ENVIRONMENTAL ASSESSMENT
OF PROPOSED REMEDIATION OF THE CHEMETRON
FACILITIES AT THE BERT AVENUE SITE
IN NEWBURGH HEIGHTS, OHIO

LICENSE NUMBER SUB-1357
DOCKET NUMBER 040-08724

CHEMETRON CORPORATION

January 24, 1997

Figure 5.1 Resident-farmer scenario doses for the Bert Avenue disposal cell with cover.

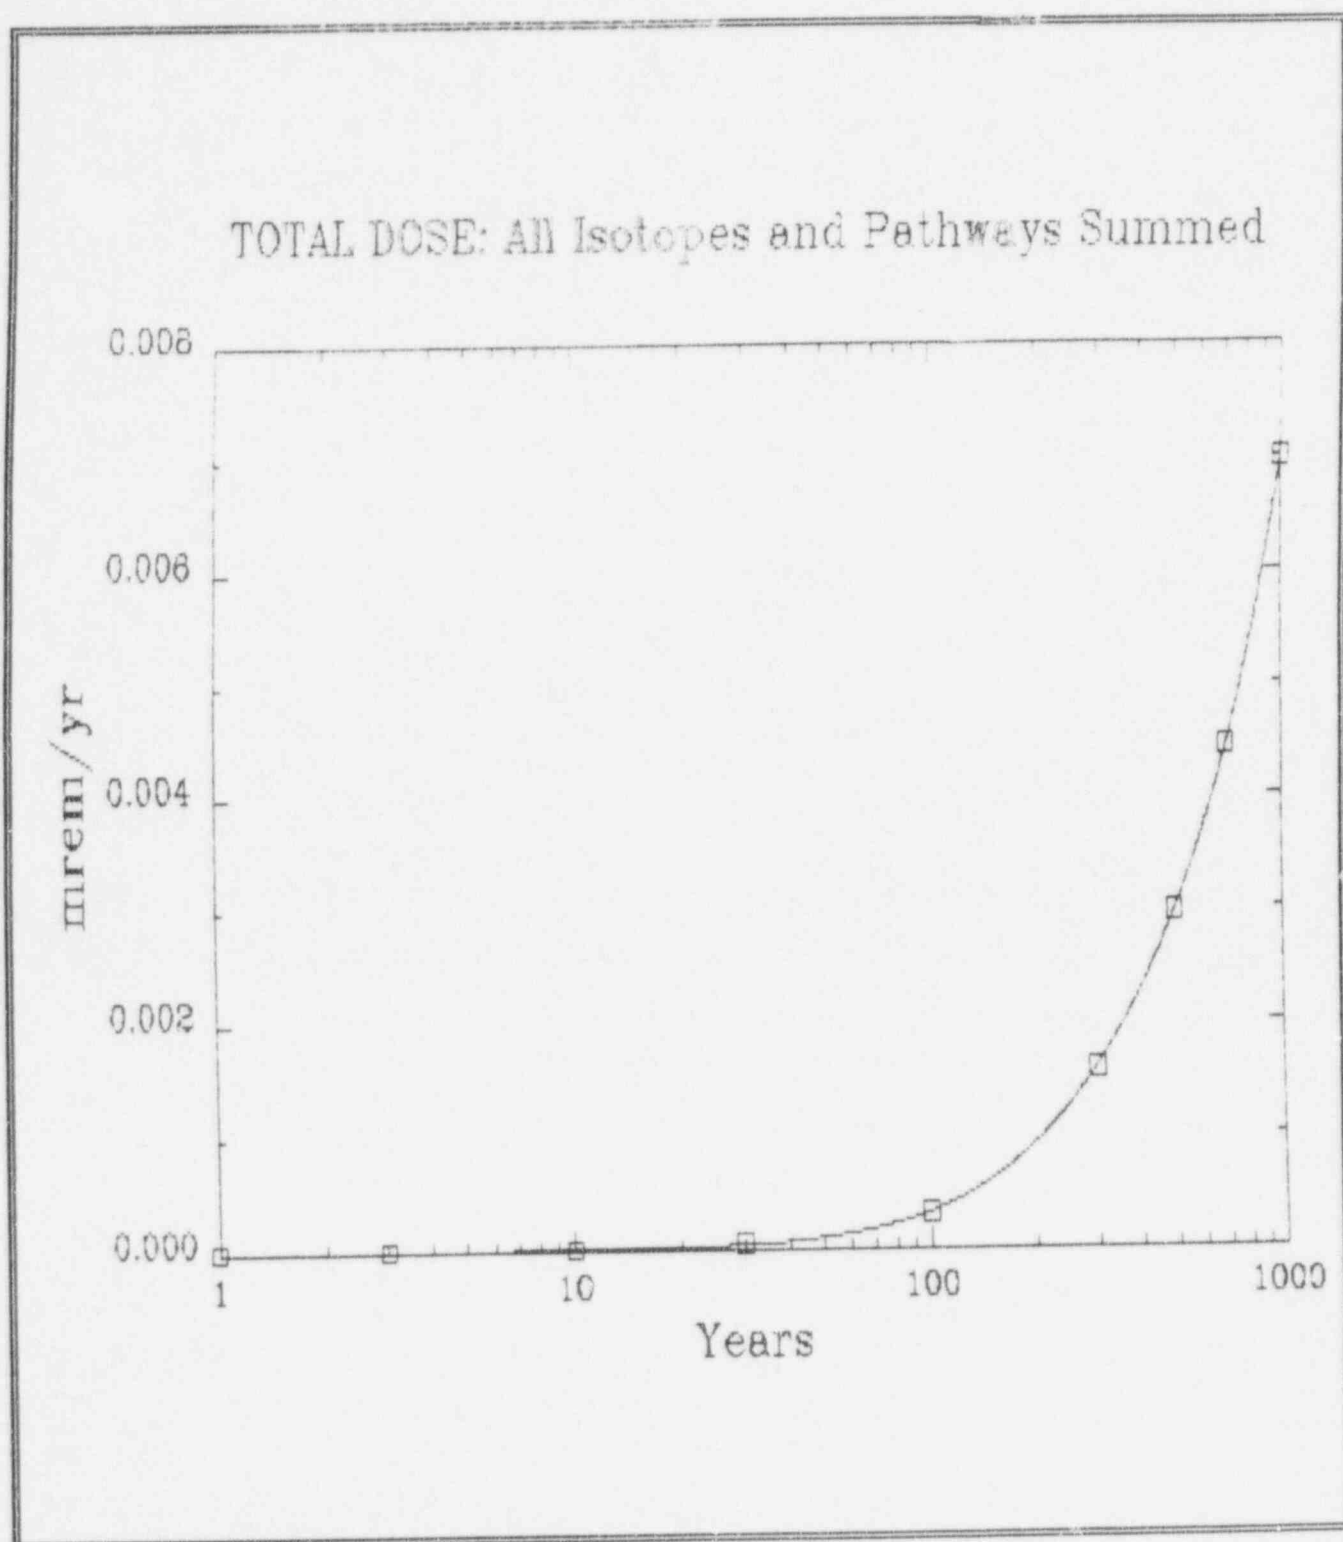
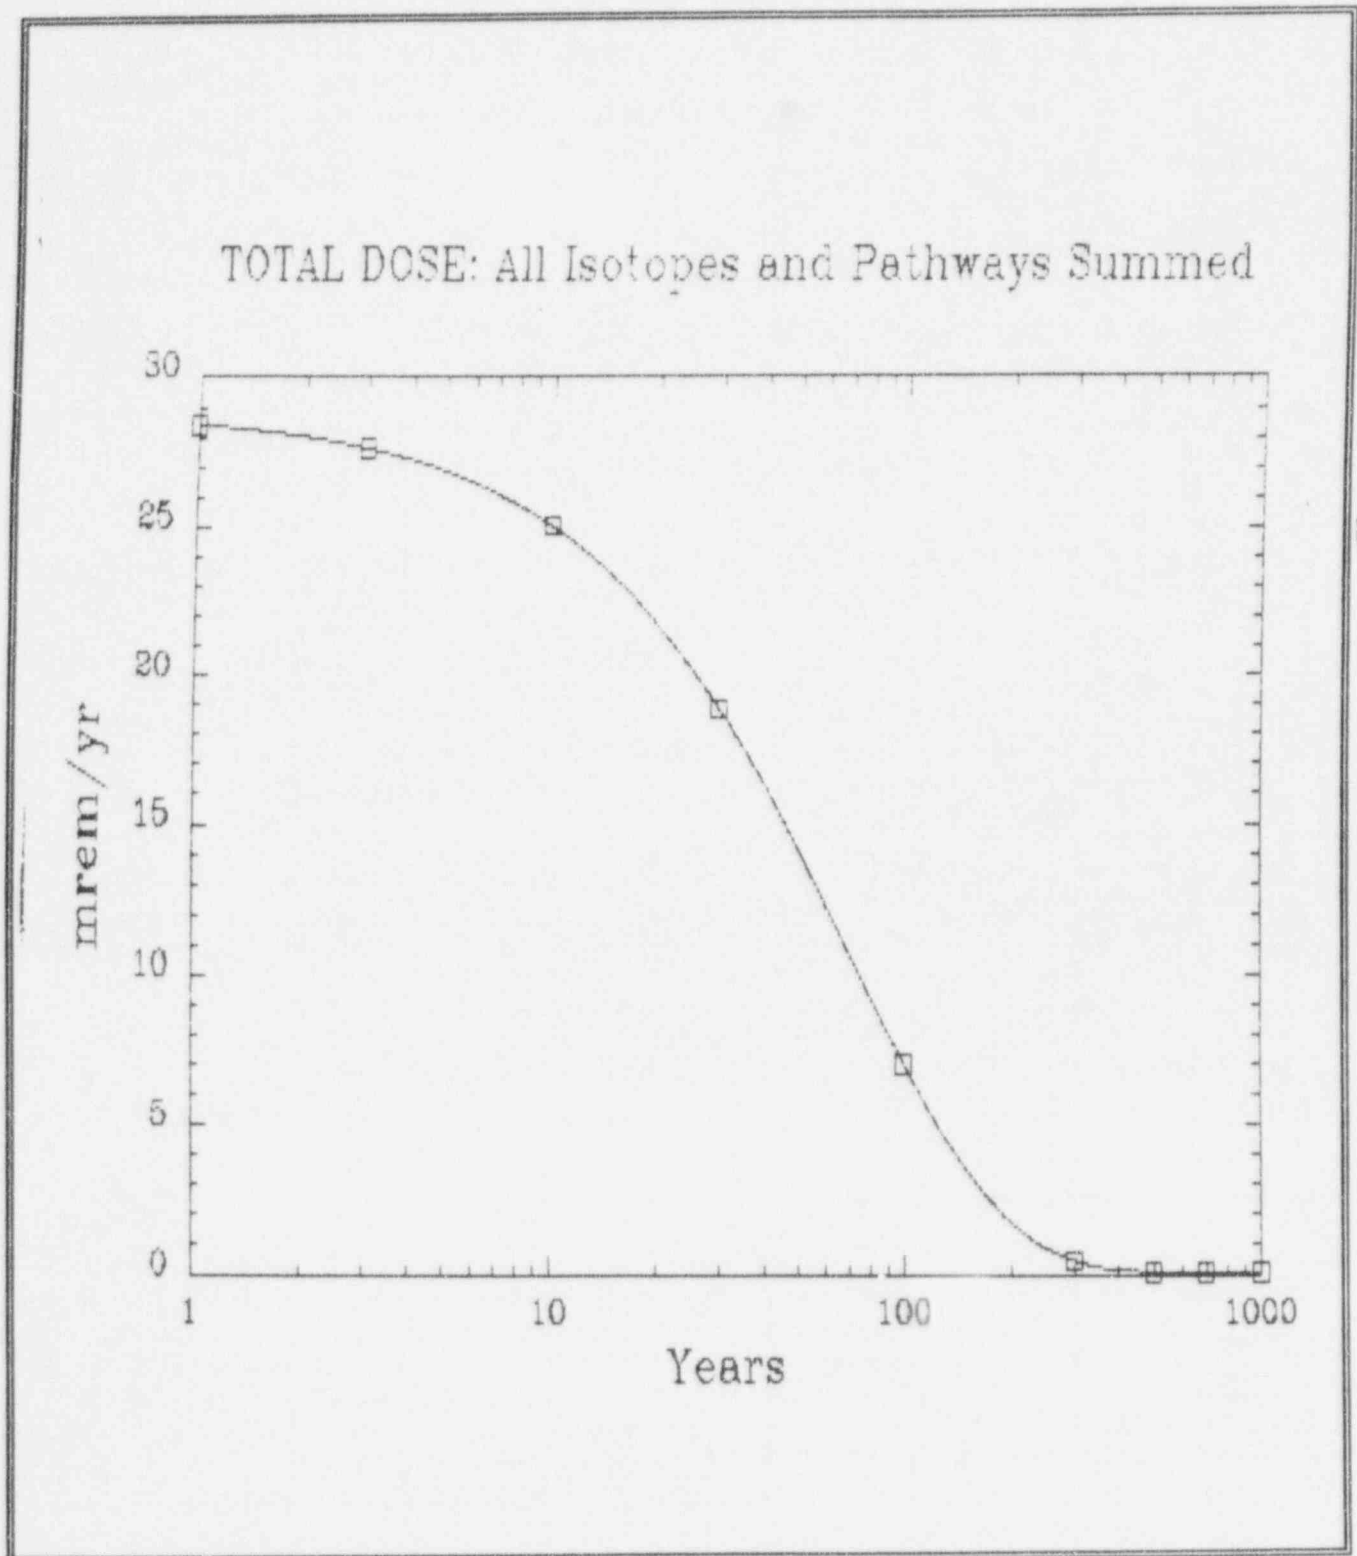
The results of the calculations are shown in Figures 5.1 and 5.2. Over a 1000-year period, the peak dose, assuming a cover and using the RESRAD code, was computed to be $7\text{E-}5\text{ mSv/yr}$ (0.007 mrem/yr). These doses include doses from the groundwater dependent pathways, such as direct consumption of groundwater and consumption of food irrigated by groundwater, and groundwater independent pathways, such as inhalation, ingestion, and direct exposure. The doses are dominated by the radon inhalation pathway. These radon inhalation

doses continue to increase from $2.5E-5$ mSv/yr (0.0025 mrem/yr) at 1000 years to about $5E-5$ mSv/yr (0.005 mrem/yr) at 10,000 years. Assuming no cover, the peak dose over a 1000-year period is 0.28 mSv/yr (28 mrem/yr). In both the cover and no-cover cases, doses result from the groundwater independent pathways (inhalation, ingestion, and direct exposure). No groundwater pathway effects were observed in the calculations during the 1000-year time period.

Figure 5.4 Conceptual model for water flow through the Bert Avenue cell assuming a rise in the water table.

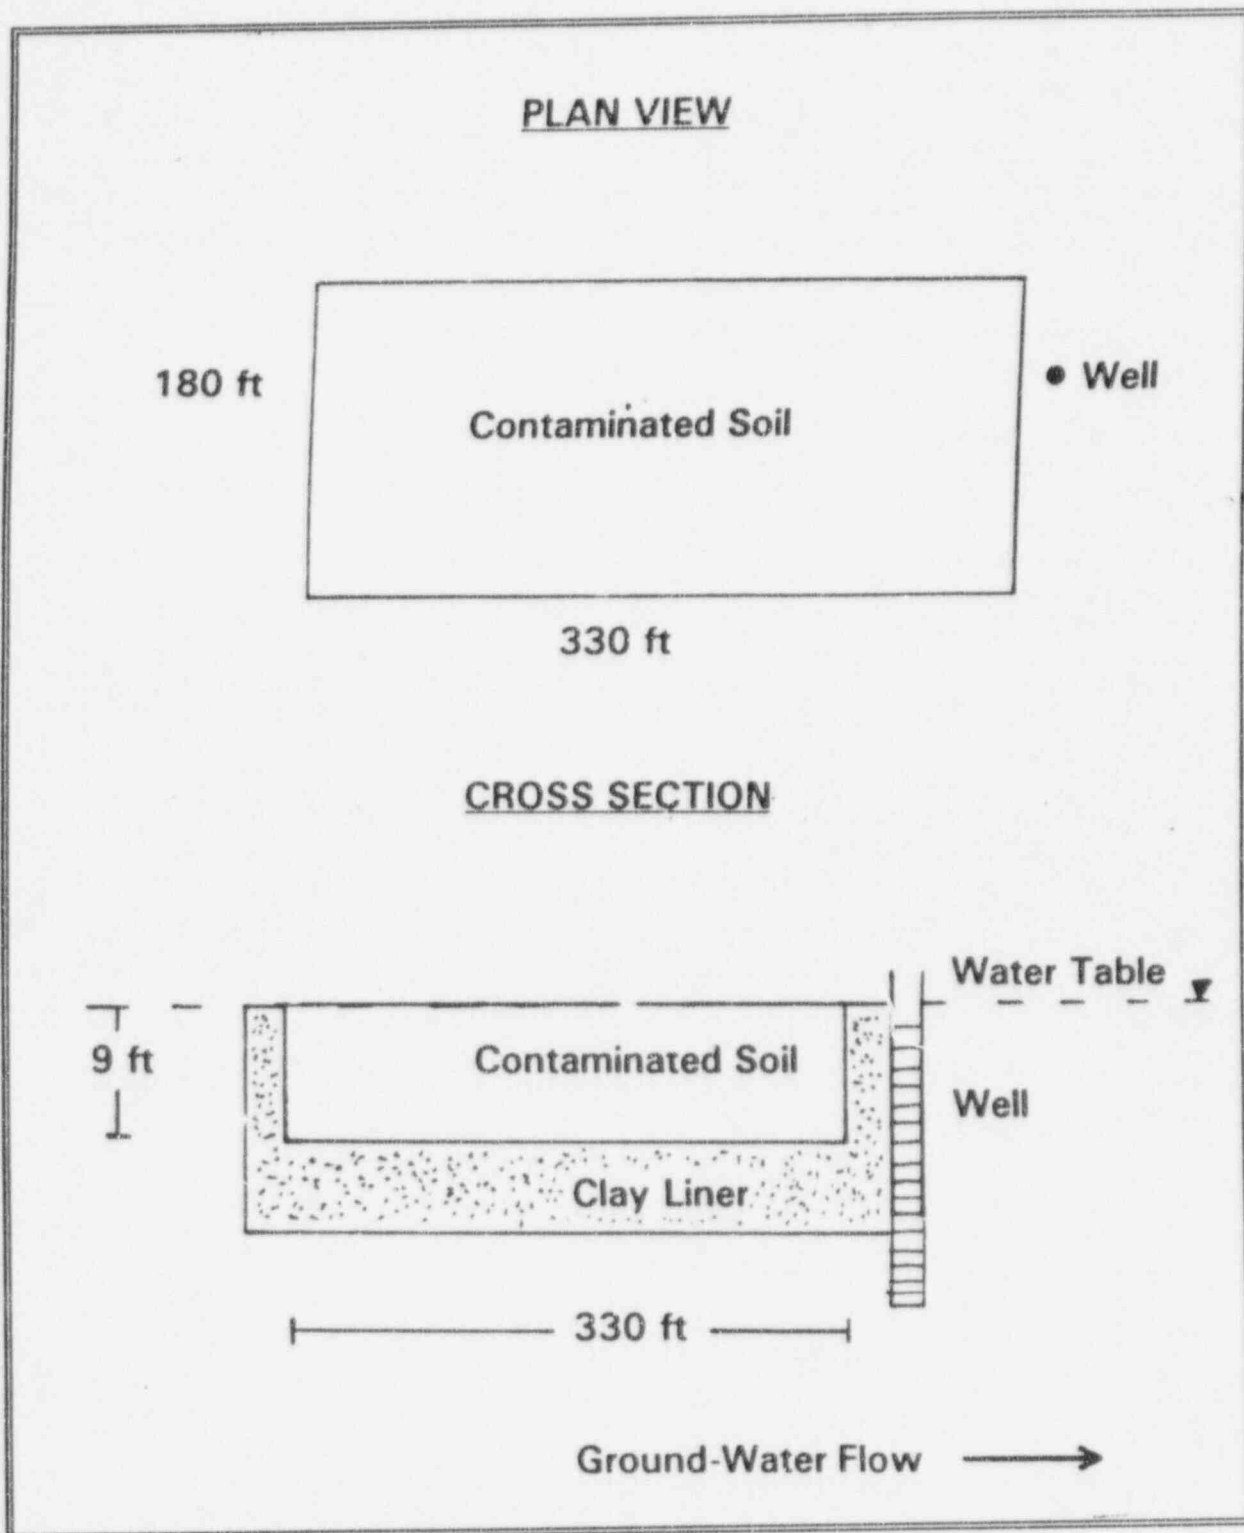
The staff evaluated the groundwater effects if the cell underdrain system ceases to function and the groundwater table rises to the level of the natural topography (see Figure 5.4). Assuming a 10 percent gradient along the longest dimension of the cell, inferred from the cell design slope, and a clay conductivity of 10⁻⁷ cm/sec (0.1 ft/yr), the water flow rate through the clay liner would be 0.46 m³/yr (16.2 ft³/yr). Using the following conservative

geochemical assumptions, the dose from uranium leaving the disposal cell, with a sufficient amount of fresh water ($4240 \text{ m}^3/\text{yr}$ ($150,000 \text{ ft}^3/\text{yr}$)) to meet the annual demand of a resident family-farmer, was computed:

Figure 5.5 Conceptual model for water flow through the Bert Avenue cell assuming local perched water conditions.

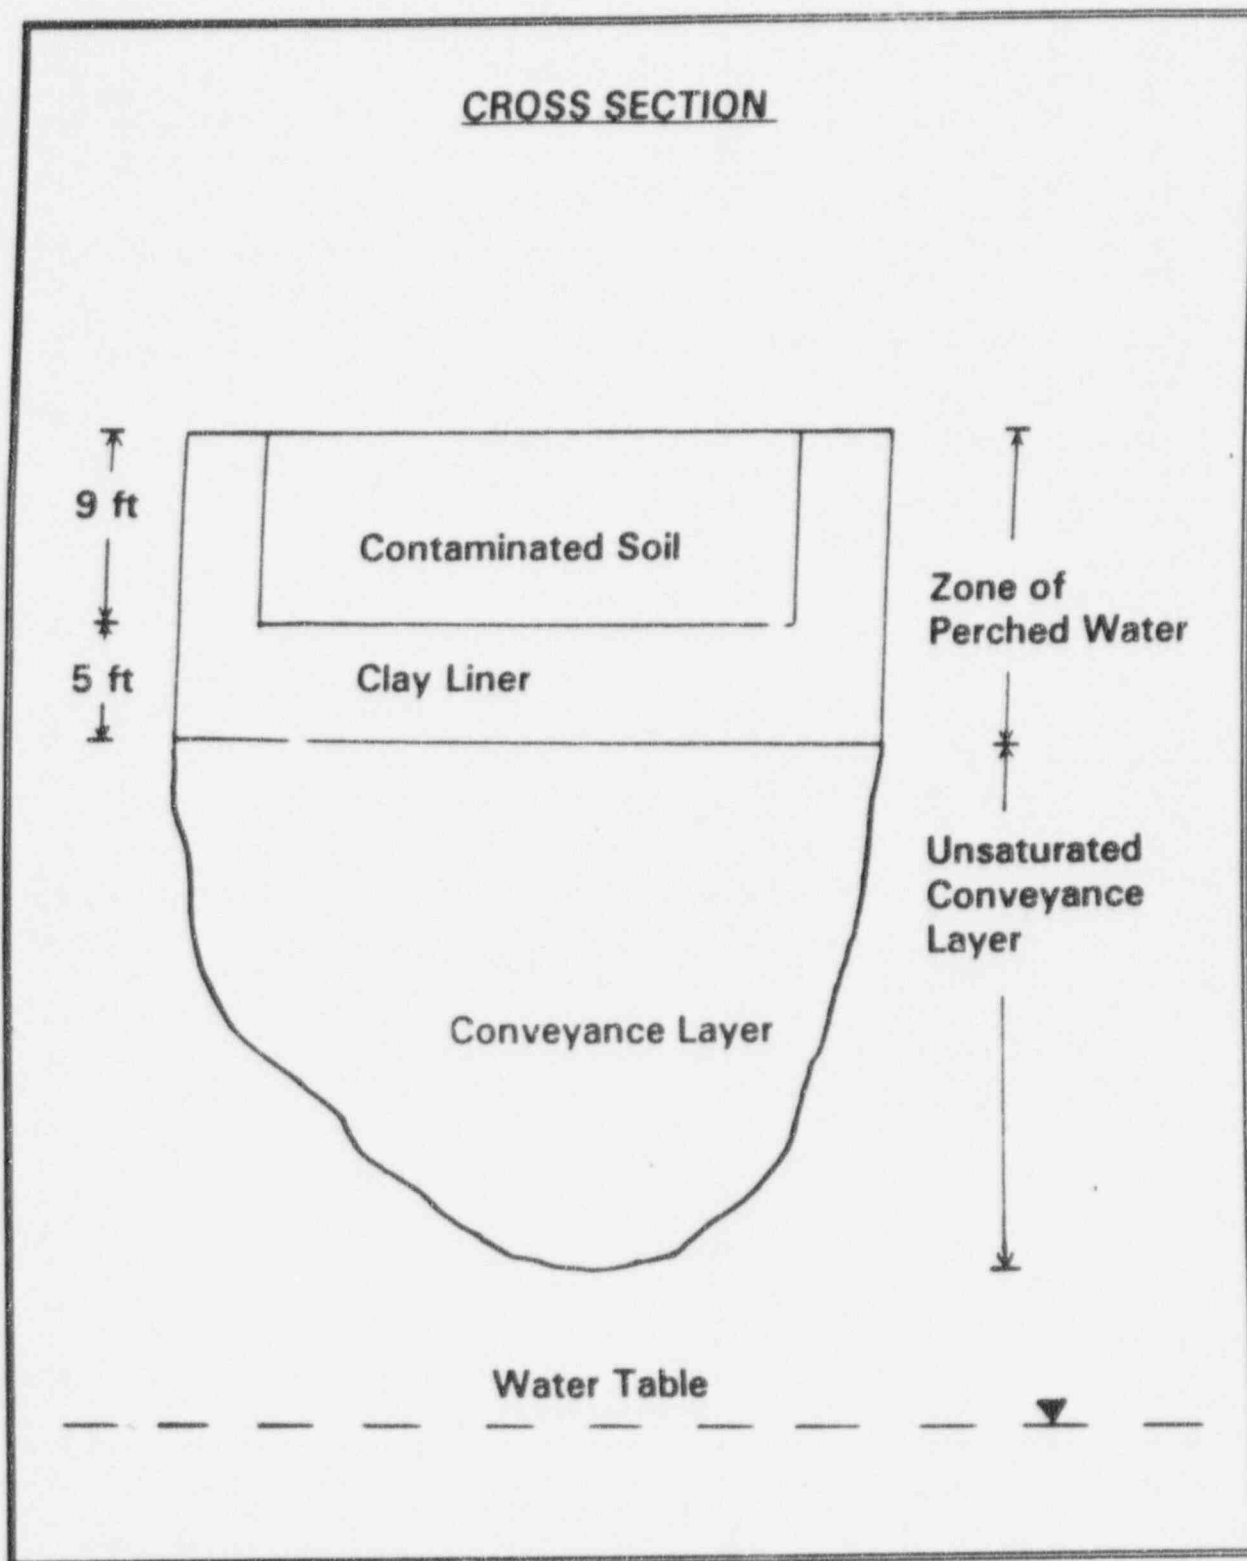
The staff also analyzed the groundwater effects if the underdrain system continued to function, but the contaminated waste layer became saturated with water forming a perched water zone (see Figure 5.5). This scenario results in a greater head for water movement through the clay liner than the scenario where the groundwater level rises to the level of the natural topography. The water flow direction is downward through the clay liner at a rate of $168 \text{ m}^3/\text{yr}$ ($5940 \text{ ft}^3/\text{yr}$). Assuming similar conservative geochemical parameters as above, the dose to an individual member of a resident family-farmer using water at a rate of $4240 \text{ m}^3/\text{yr}$ ($150,000 \text{ ft}^3/\text{yr}$) would be 0.26 mSv/yr (26 mrem/yr) at 1000 years and the peak dose would be 0.71 mSv/yr (71 mrem/yr) at 1650 years.
